LASER INTERFEROMETER GRAVITATIONAL WAVE OBSERVATORY

LIGO-T080233-01-D

## Beam Splitter Optical Surface Deformation due to Gravity

**Figure 2: Front Surface Normal Displacement (see note below)**

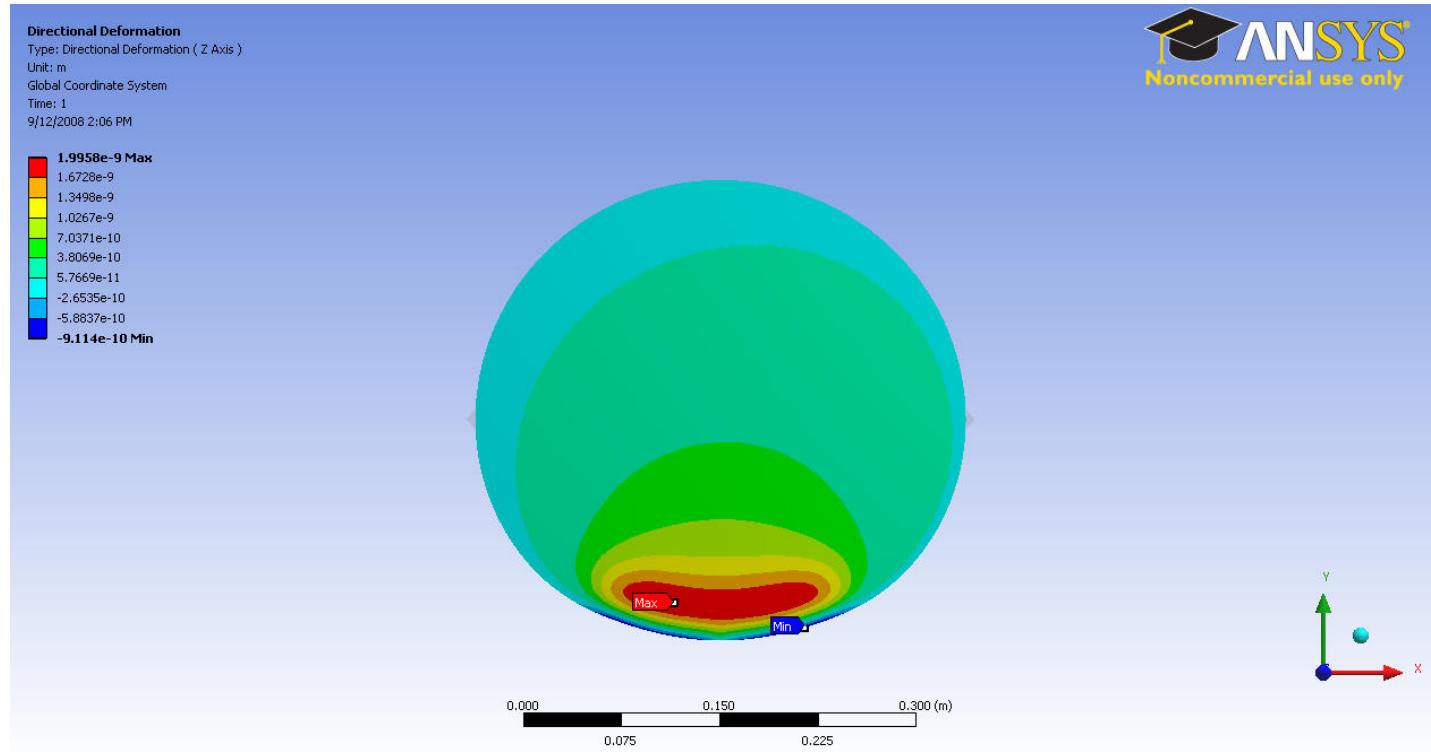
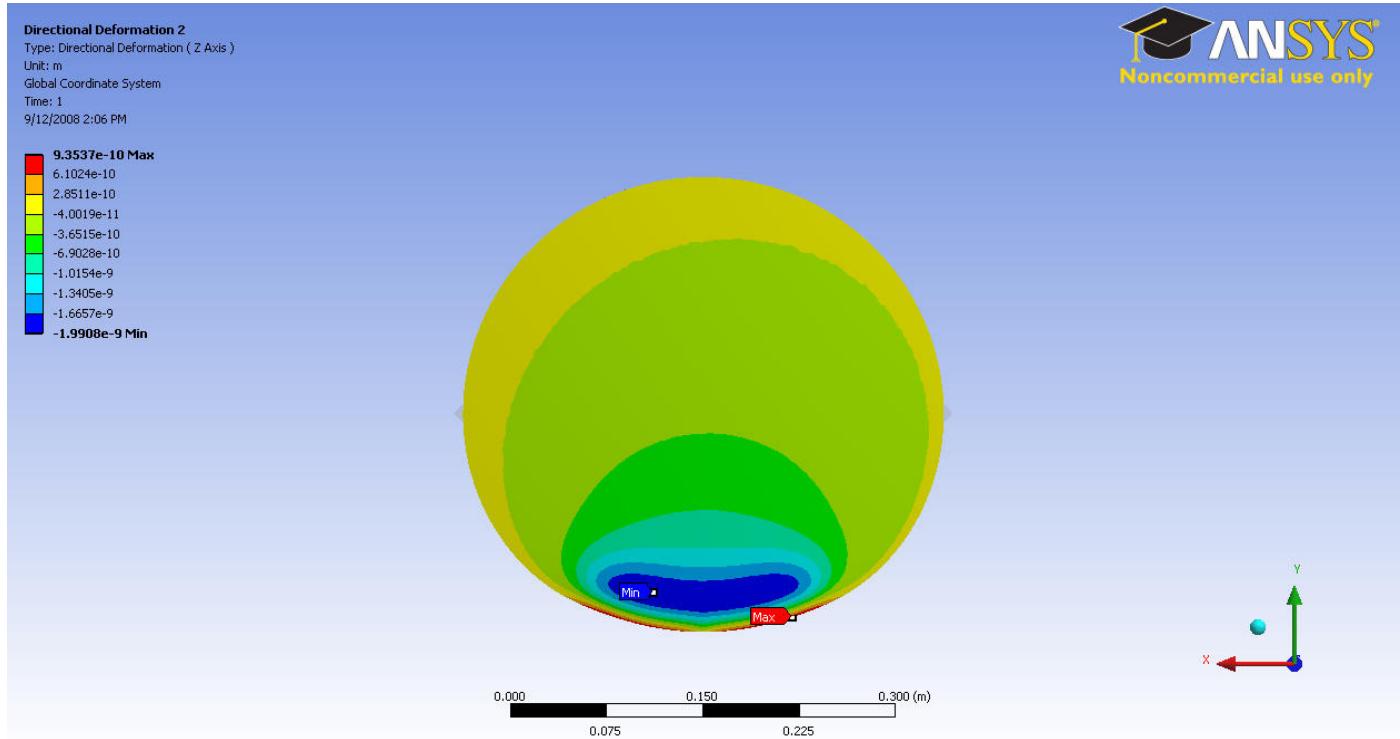
One is about fig2 and fig7. These two figures show peak positions at off center, and it looks like left-right symmetry is broken.

The actual distribution has two peaks at the symmetric positions and, due to numerical precision, it happened that one of the peak was infinitesimally larger than the other. A short comment would relieve unnecessary wonders.

Figure 2 and figure 7 show peak positions at off center, and it looks like left-right symmetry is broken. The actual distribution has two peaks at the symmetric positions and, due to numerical precision, it happened that one of the peak was infinitesimally larger than the other.
